Subject: City of Midland Landfill
Landfill Gas Collection and Control System Construction
Addendum #1

On behalf of the City of Midland (City), CTI and Associates, Inc. (CTI) presents this letter, including attachments, to serve as Addendum # 1 to the Project Manual (including Drawings) for Landfill Gas Collection and Control System (GCCS) Construction at the City of Midland Landfill (Landfill).

Cell 14 Leachate/LFG Interceptor Survey Information

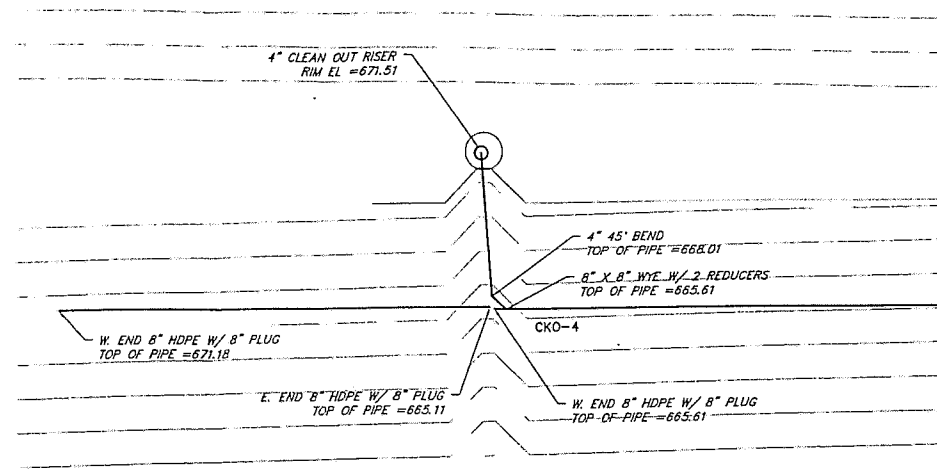
- Plan View, Survey information for the existing leachate/landfill gas interceptor trench can be found in Attachment A.
- Plan View, topographical information for Cells 14 & 15 will be updated prior to construction.
- Plan View, existing refuse fence located near the west edge of Cell 14 shall not be damaged. Contractor shall not disturb poles and shall work with the Owner to coordinate the temporary removal of netting to install gas lateral lines for remote wells in Cell 15.

BORING LOCATIONS AROUND LFG COMPRESSOR FACILITY
 CITY OF MIDLAND LANDFILL
 MIDLAND, MICHIGAN

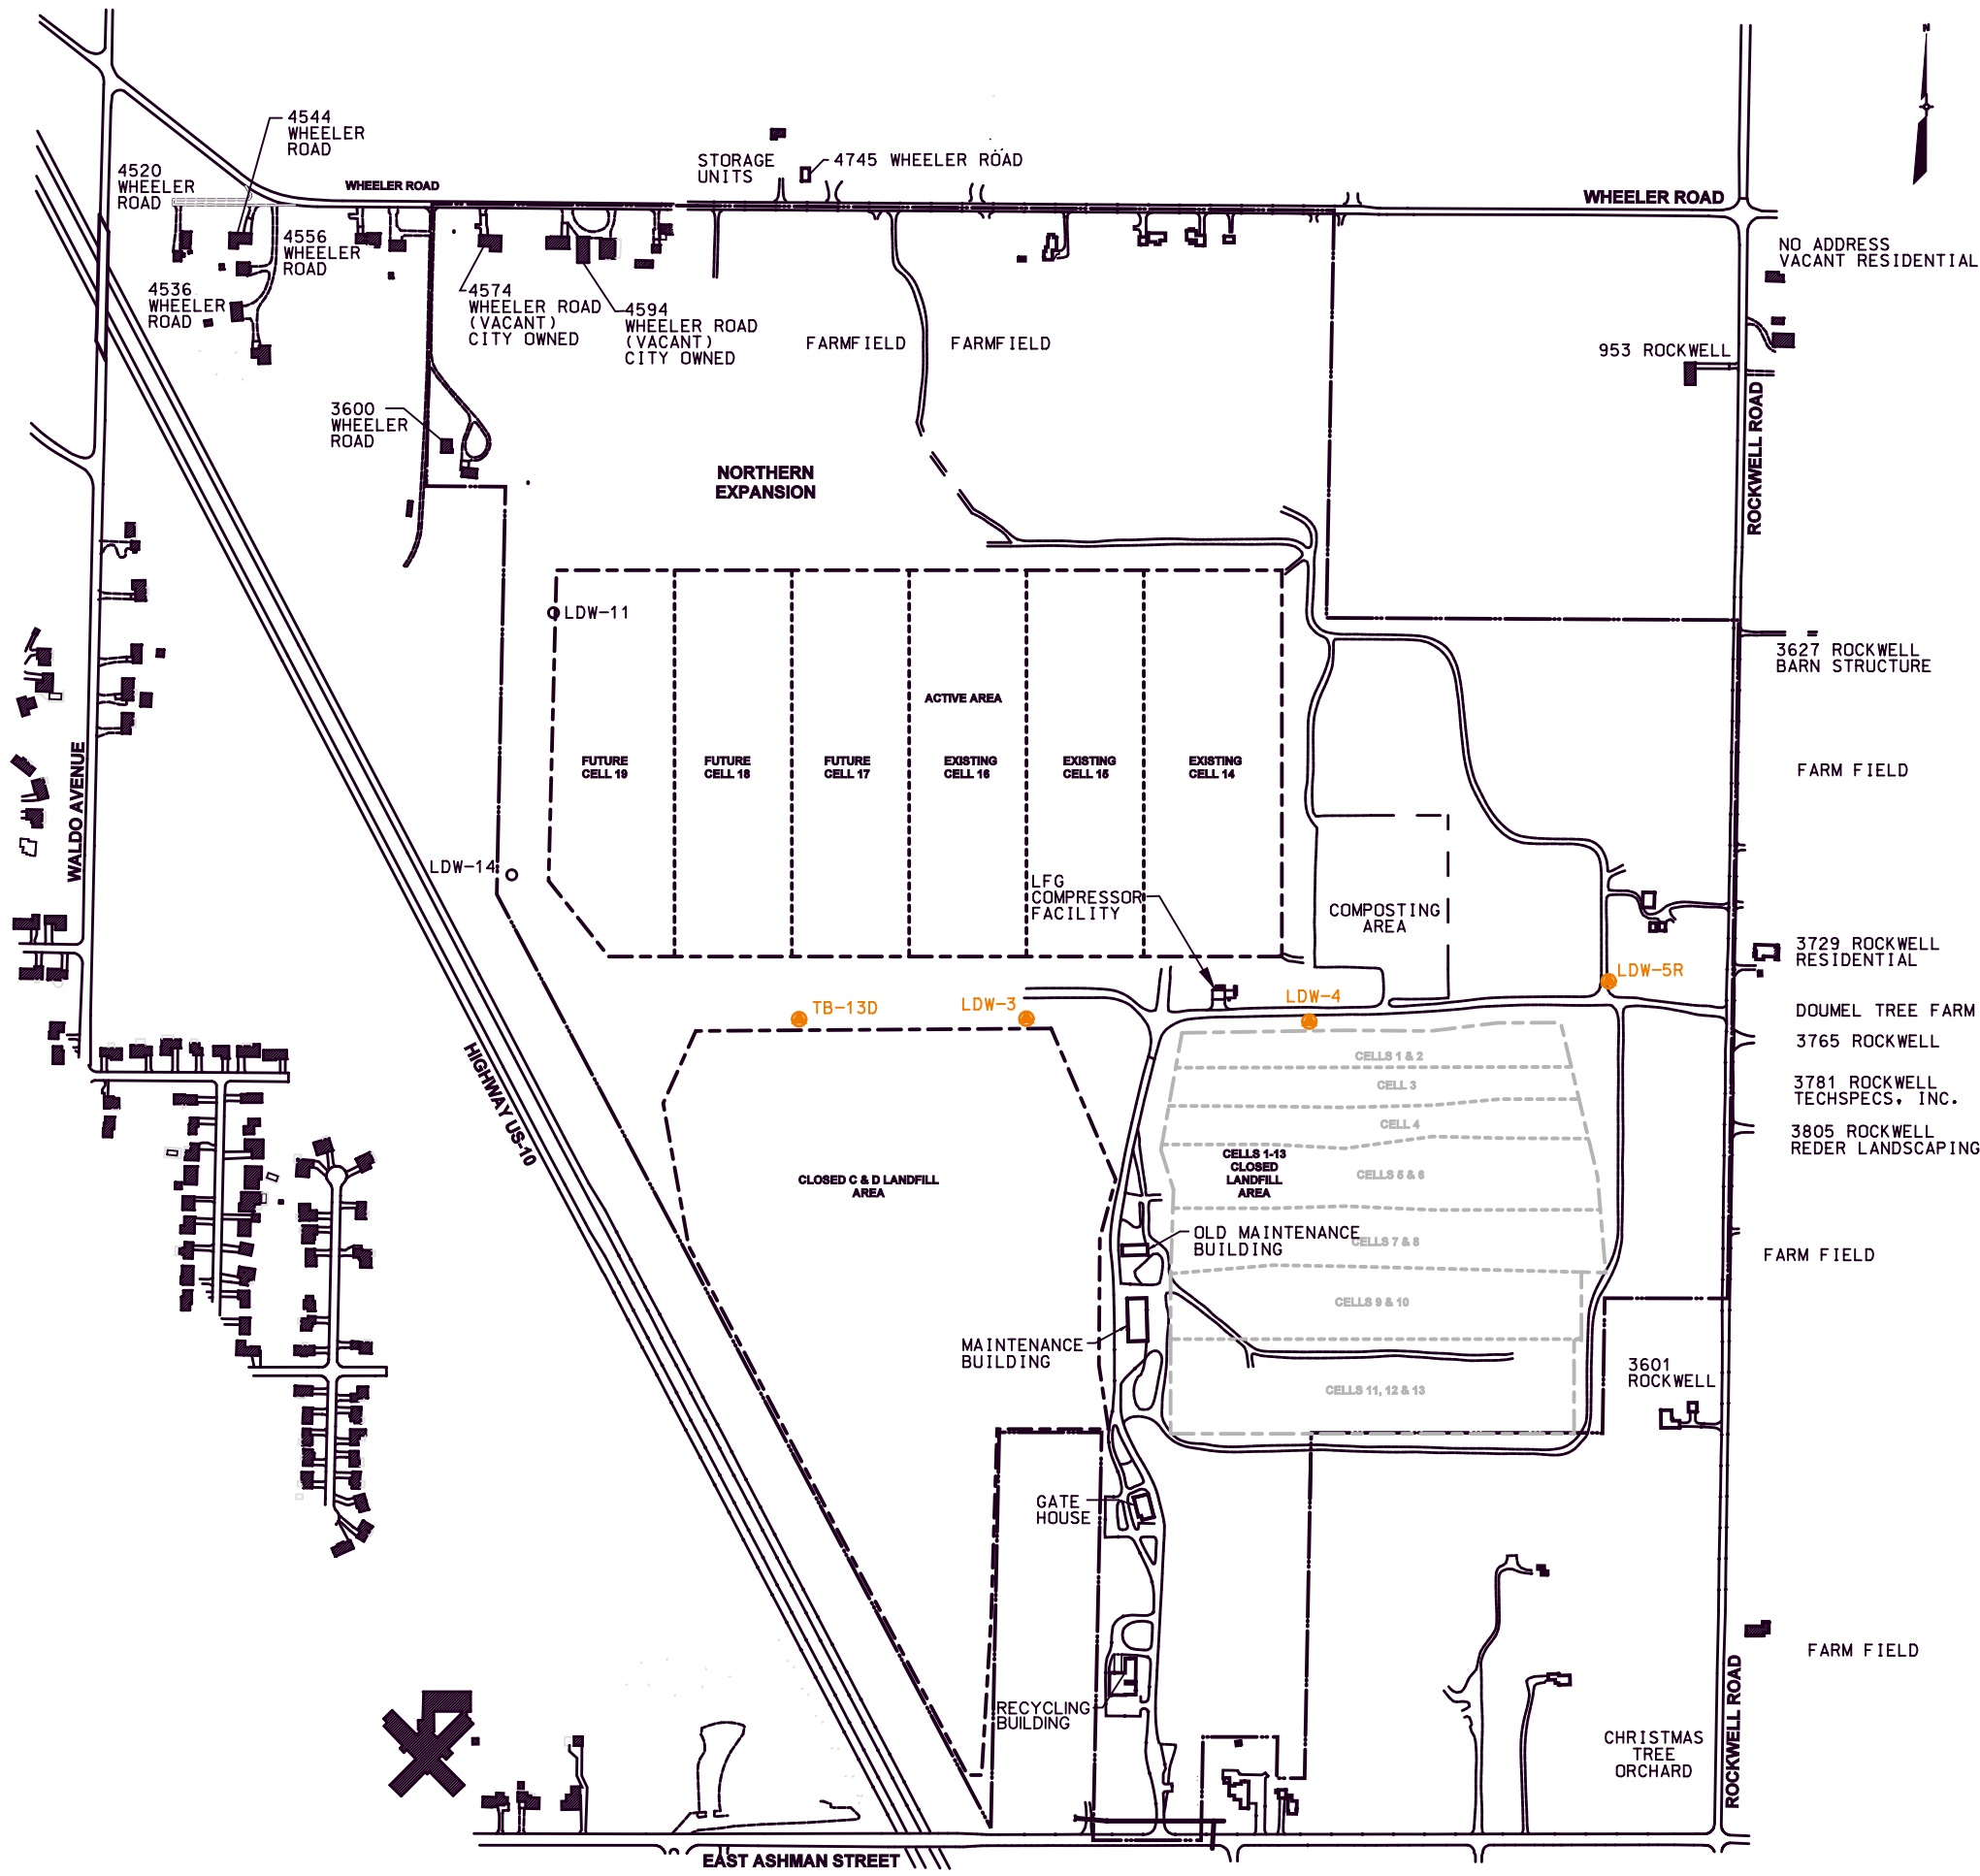
11. The excavation for the Dual Contained Lift Station at the Flare area will be 20 feet deep and will be a major undertaking. Is there information available on groundwater levels in this area? Will dewatering be necessary?

Well/boring log data for wells located in this area are provided in Attachment C. It is not anticipated that the Contractor will encounter any significant amounts of perched liquid. However, previous cell construction has uncovered drain tiles from agricultural activities performed at the site when it was used for farming.
